Remote Link and System Link January 2007

Version 1.34 Software Update

Backup Type

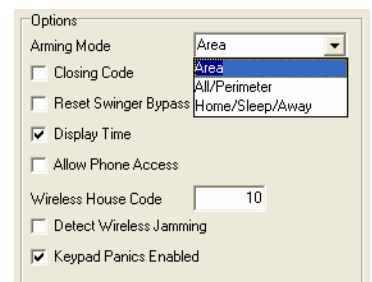
RS-232: On XR500 Series panels version 118 or higher, RS-232 displays on the **Backup Type** menu if **Net** is selected under **Communication Type**. The RS-232 option is primarily used for radio backup communications.

Messages are sent using RS-232 after they have failed to communicate with the programmed Primary NET IP and Backup IP. Select RS-232 when using DB-9 backup communications by directly connecting to the RS-232 port on the panel. Set the panel J23 jumper to R and briefly reset the panel using the J16 jumper to activate RS-232 operation. Refer to the XR500 Series Installation Guide (LT-0681) or the XR2500F Installation Guide (LT-0759).

When Net Backup is YES and a Modem String is programmed, an Automatic Recall test is sent using the RS-232 line based on the normal programming selections in Test frequency, Net Fail Time, Defer Test Time, and Test Time options just as they do for DD. When the RS-232 automatic recall test fails to communicate, a Warning: Panel Backup Communications Fail (S12) report is sent using the Primary NET IP. The next time the panel successfully sends a report over the 2ND LINE, a Backup Communication Line Restore (S04) report is sent.
